August 3, 1984

HOPE CREEK GENERATING STATION  
DOCKET NO. 50-354  
DRAFT SAFETY EVALUATION REPORT  
OPEN ITEM STATUS

In addition, enclosed for your review and approval (see Attachment 4) are the resolutions to the Draft SER open items, FSAR question responses and structural geotechnical audit item responses, listed in Attachment 3.

FIGURE A-13-35

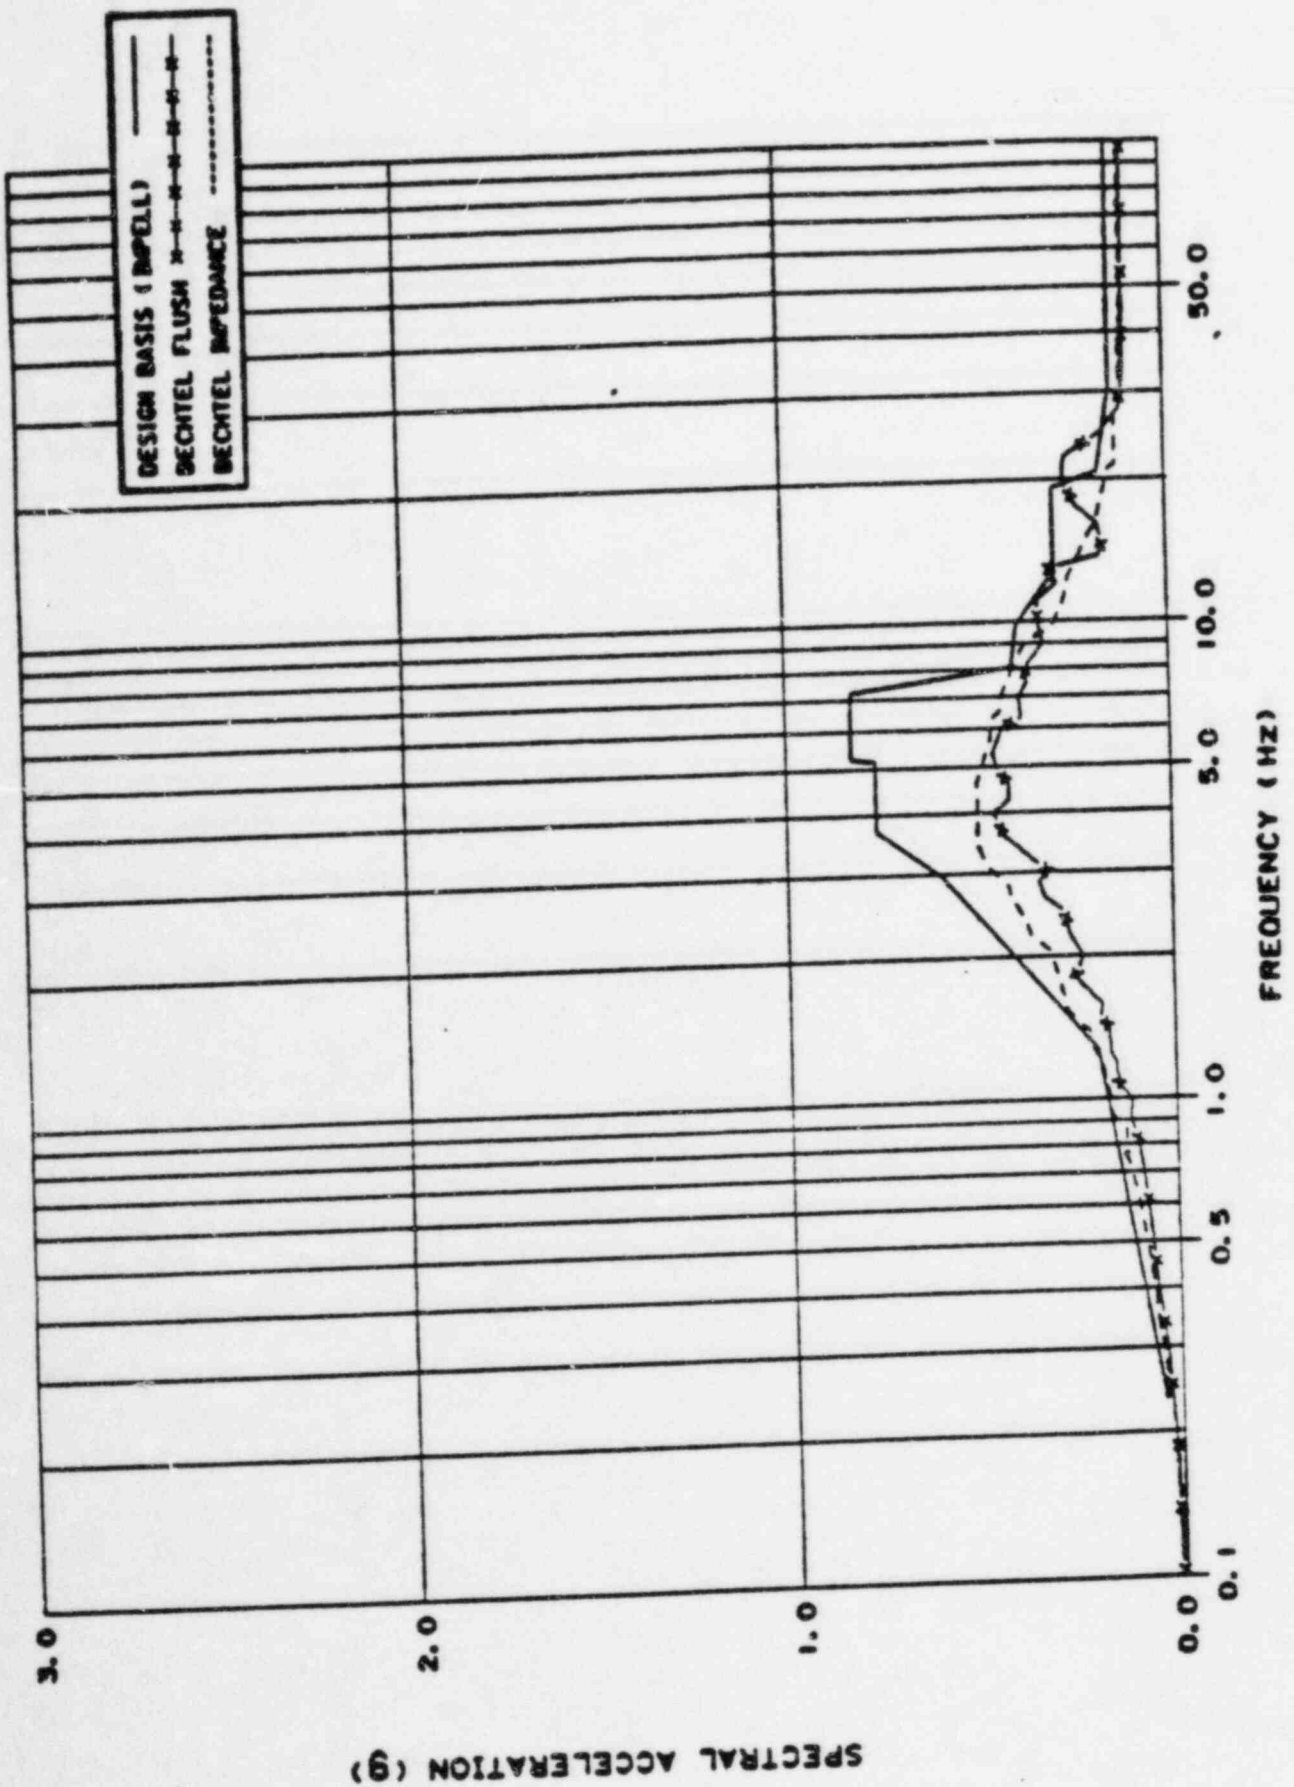
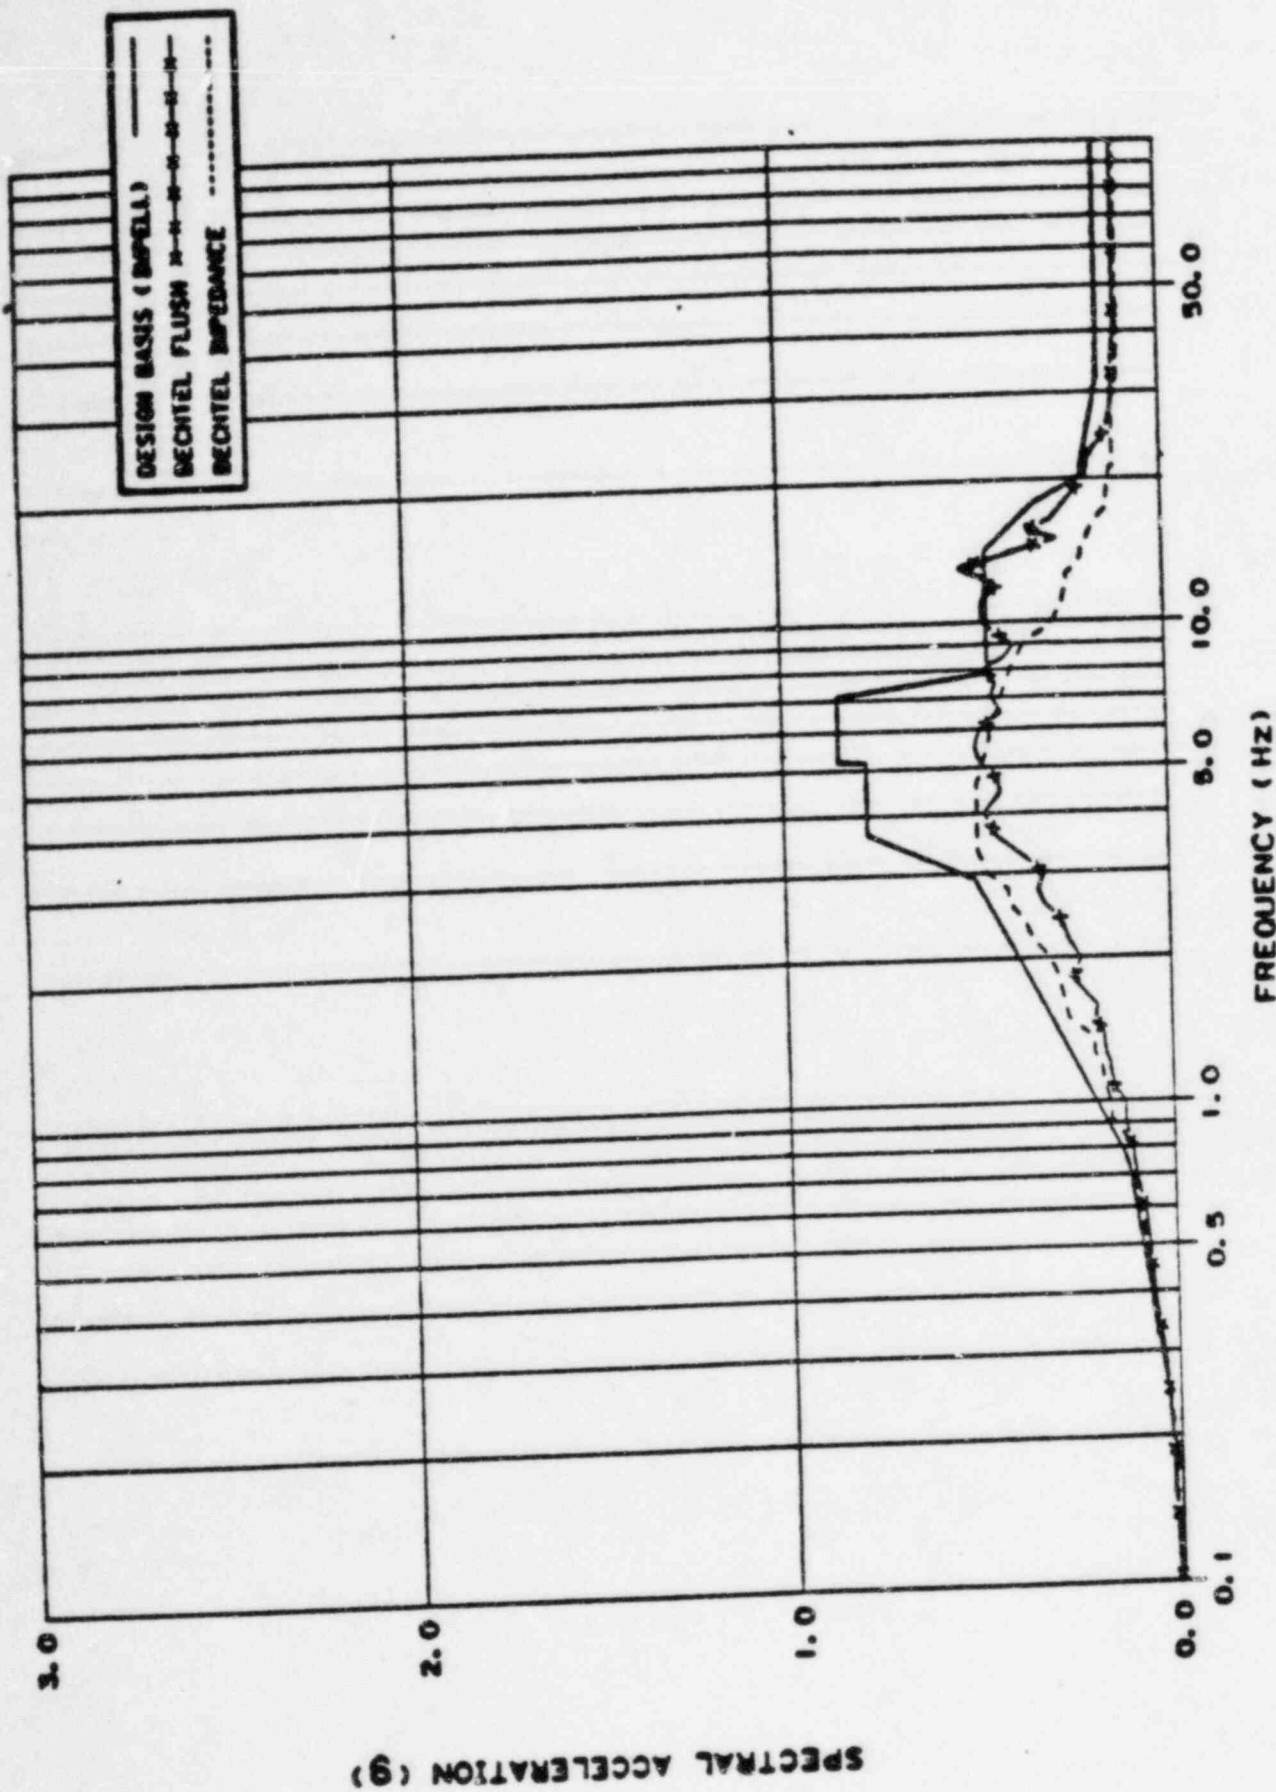
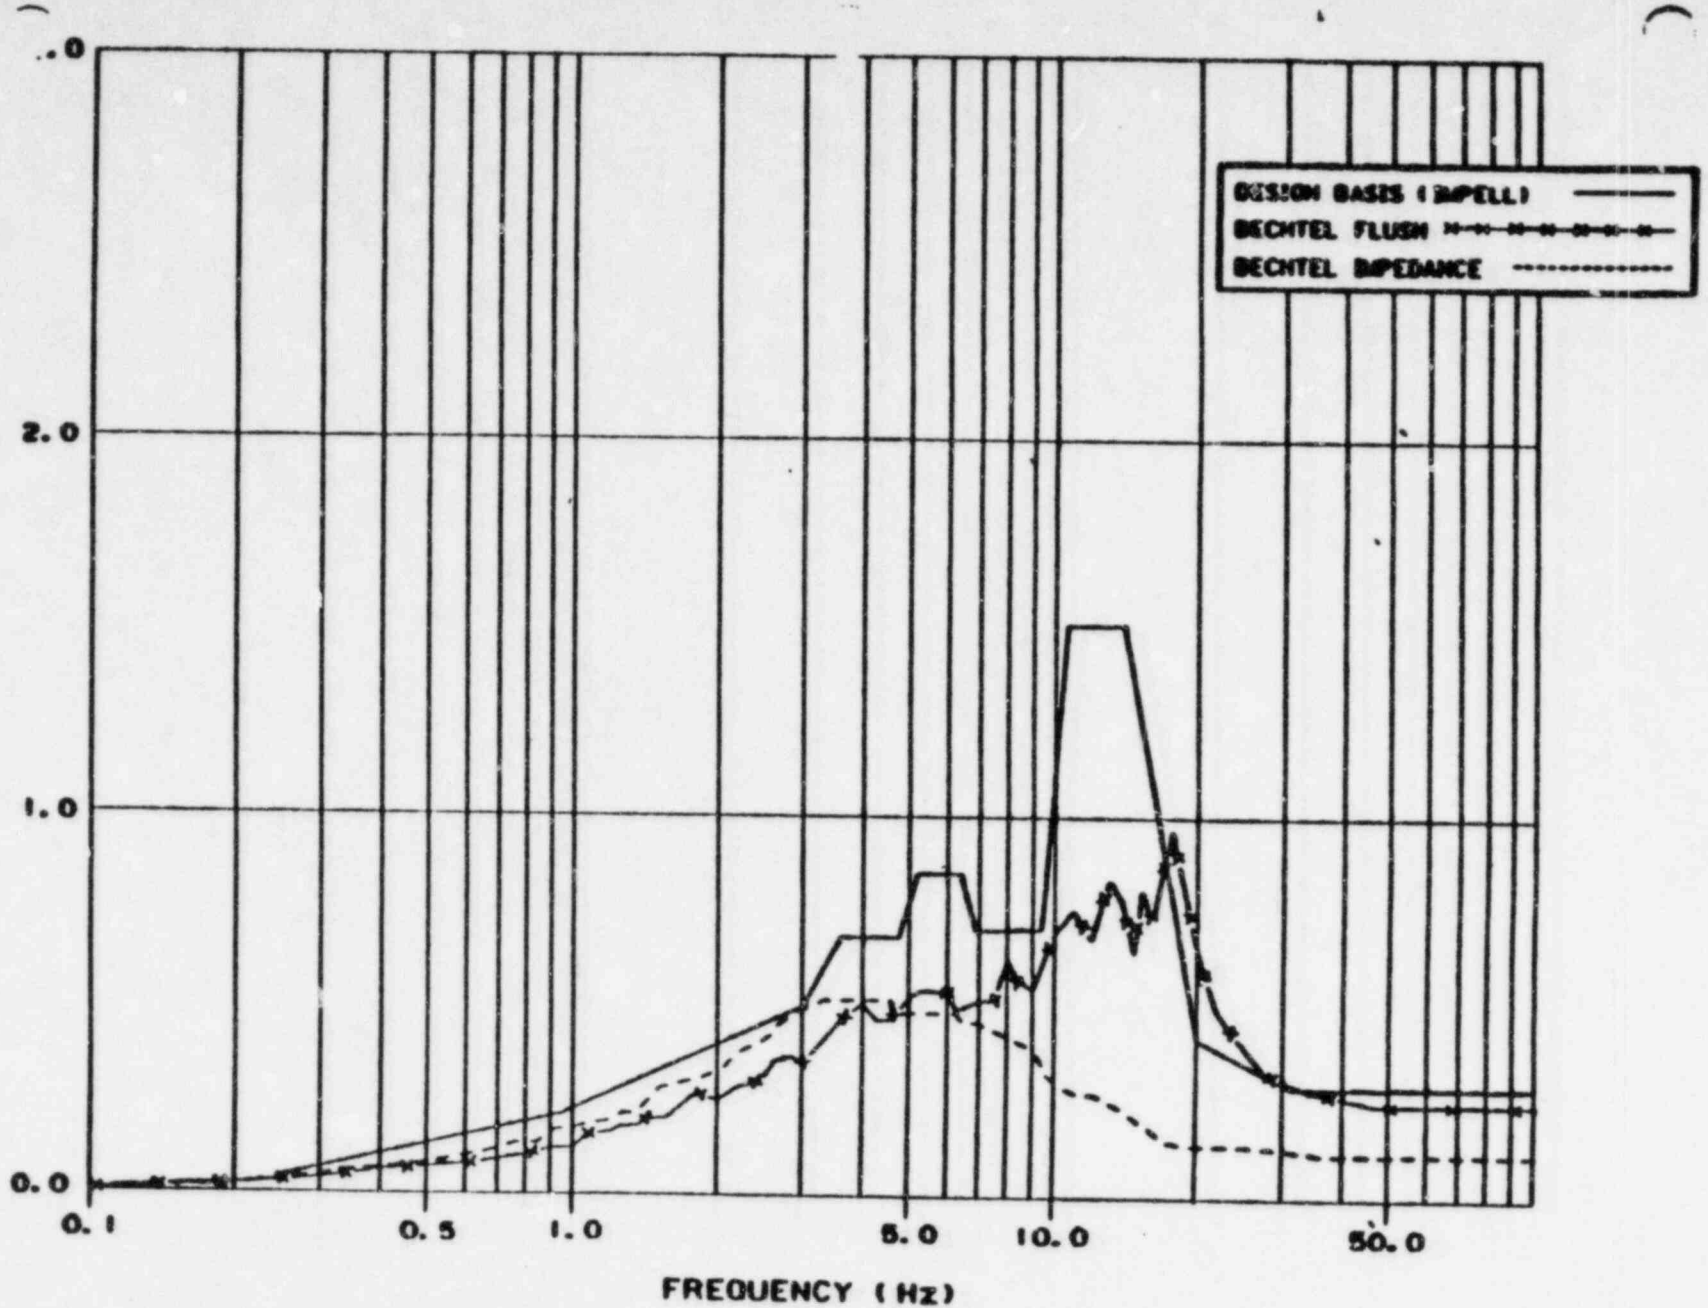
Question: Provide comparison of Bechtel Independent Verification Results with the Design Basis Results.

Figures A-13-2 to A-13-37 show the comparison of the response spectra (2% damping) obtained from the above three seismic soil-structure interaction analyses. Discussions of these comparisons are as follows:

Bechtel's independent soil-structure interaction analyses are performed using the computer code FLUSH. The results of independent finite element analyses are in reasonable agreement with those of the design basis analyses. As can be seen from Figures A-13-2 through A-13-37, the horizontal response spectra obtained from the independent finite element analyses are generally enveloped by those obtained from the design basis analyses except for the frequency range lower than 2 Hz. The vertical response spectra showed some exceedances at the frequency range of 18 Hz. These exceedances are listed in Table A-13-1.

The peak spectral accelerations obtained from the impedance approach analyses are generally lower than those obtained from the design basis analyses. However, these response spectra are not completely enveloped by those obtained from the design basis analysis, especially in the frequency range between 1.0 and 3.5 Hz. Also, there are some local exceedances in the higher frequency range, as shown in Figures A-13-2 through A-13-37.
